CITY OF DALLAS

RE: Appeal of Certificate of Appropriateness:
Hearing – October 3, 2022
4512-4518 Sycamore St., Case No. CA212-354(RD)

**4512-4518 SYCAMORE
STREET
APPEAL
CA212-354(RD)**

**City Plan Commission
Hearing
01/05/2023**

Photo #1 (duplex #1)

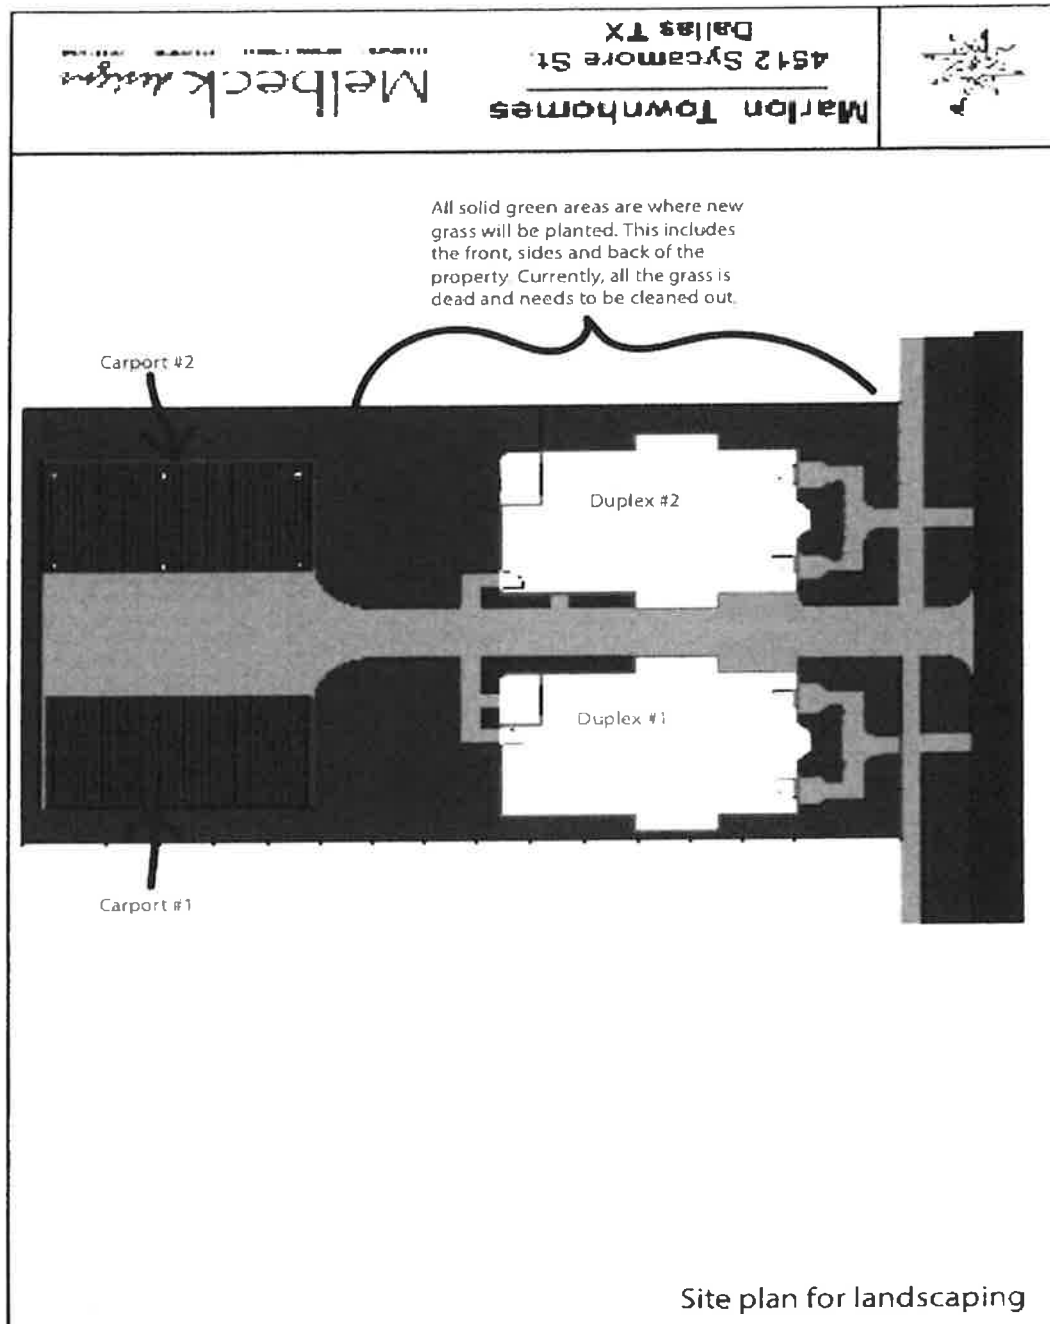
The applicant proposes to replace a chain link fence, around rear and side yards with an eight-foot high, (pine) wood picket fence. According to the applicant, the prior fence was in disrepair and vagrants were entering the property through holes in the fencing. The newly installed fence is a privacy fence; however, the side elevations of both buildings are visible from the public right-of-way.

Photo #2: New wood fence that was installed. Followed the same footprint as the chain link fence. It measures 8 feet tall for added security and 83 feet long. It also updates the overall appearance of the property and makes it look clean and aesthetically pleasing.

2. That the request for a Certificate of Appropriateness to replace chain link fence around rear and side yards with wood fence be **approved** as submitted.

SASH - EXPLODED VIEW

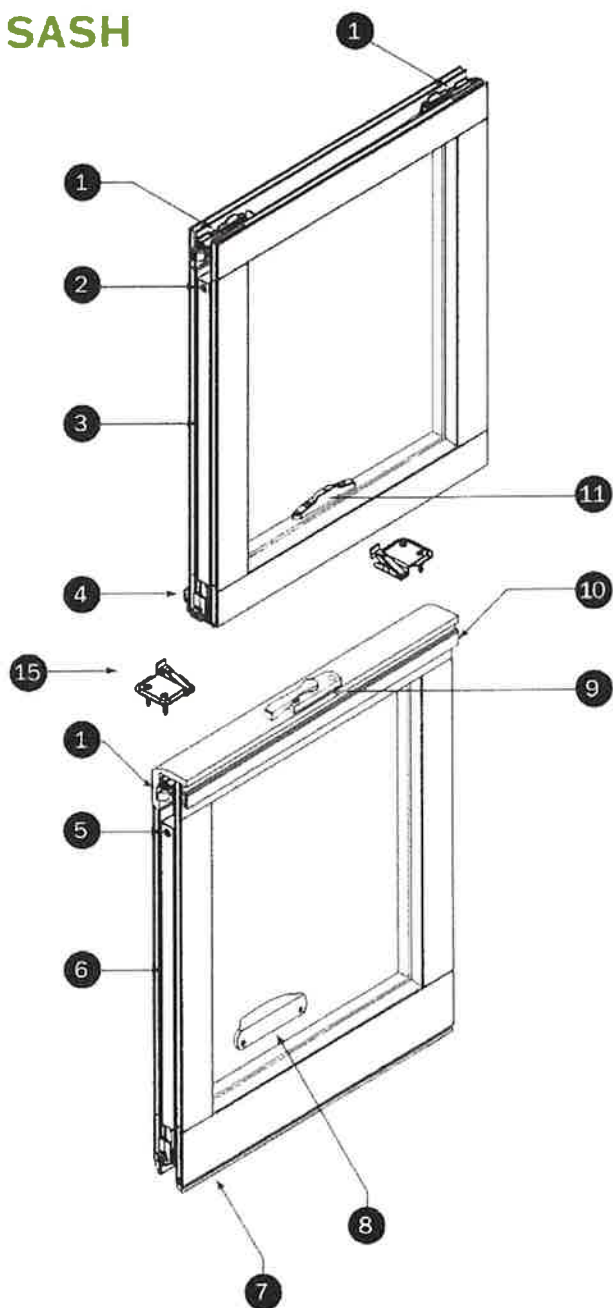
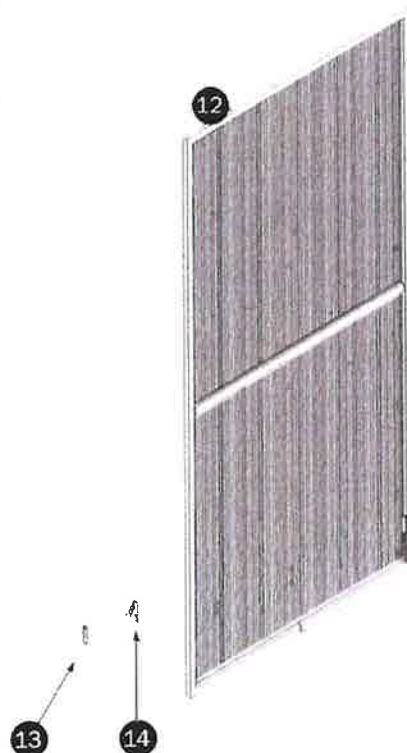
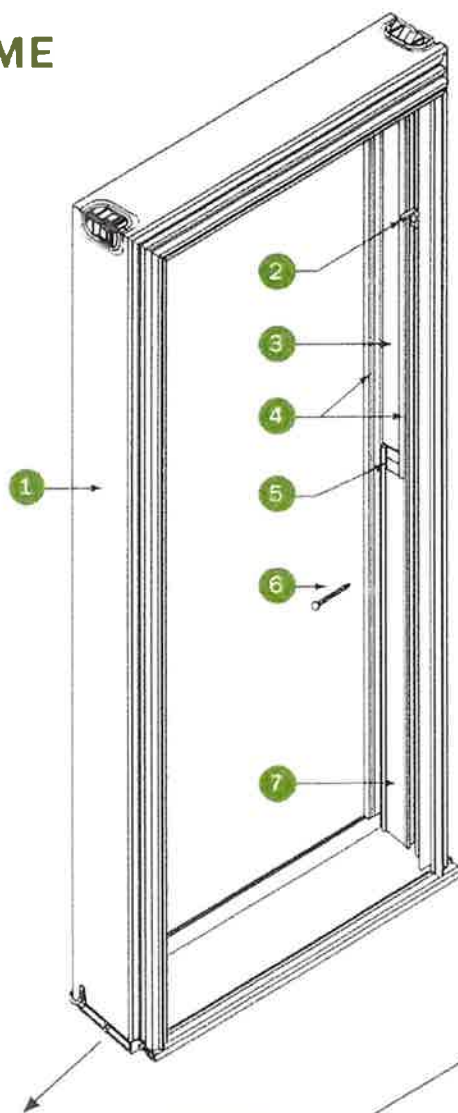
2 don't see on the detail that's provided
3 that -- it looks like the meeting sash
4 is the same dimension as the side rail
5 sashes and the top rail sashes. I don't
6 see a difference between your meeting
7 rail sash. That's a very prominent
8 feature on historical windows, interior
9 windows, and I don't see that.

14 COMMISSIONER CUMMINGS: No, I'm
15 talking about the bottom sash. There's
16 also indications of differences on the
17 thickness of the meeting sash, but let's
18 just talk about the bottom sash. What's
19 your dimension on your bottom sash? And
20 I also don't see a sill detail that was
21 called out, and you had three choices on
22 the windowsills.

11 COMMISSIONER CUMMINGS: Correct.
12 It doesn't seem like there's a
13 difference between the bottom sash
14 dimension and the side dimension.

5. That the request for a Certificate of Appropriateness to replace wood windows with wood composite windows be **denied**. Wood composition windows are not wood, and these windows would have an adverse effect on the historic district. Work is not consistent with 51A-4.501(g)(6)(c)(ii) for non-contributing structures. Proposed work is not compatible with the historic district.
